**Report: TAB REPORT
Function: Test, Adjust, & Balance
Date: 12/29/2022**

12-26 CULVERS - GREEN BAY, WI (FACILITY TAB)

Project Summary

Issue Name : 1. PRV-1 (Restrooms) Fan is Not Operational.

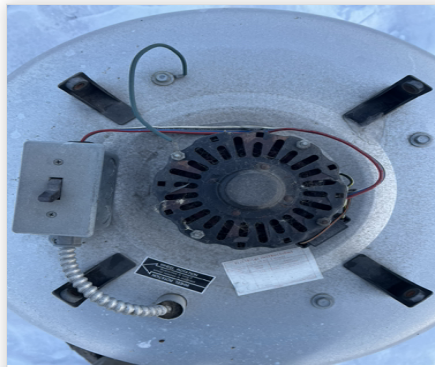
Description : Fan is not operational. Motor may need replacement. Recommend service.

Issue Name : 2. PRV-4 (Dish Hood HD-3) Fan Not Operational

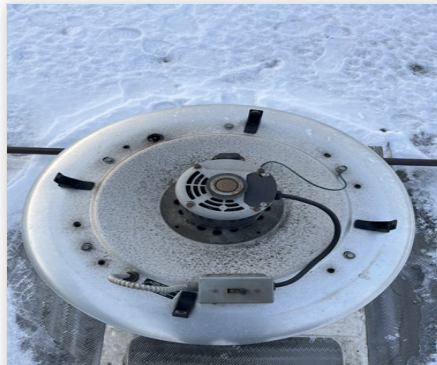
Description : Fan is not operational. Needs service. Recommend fan operation is tied into dishwasher operation if repaired to help maintain building pressure.
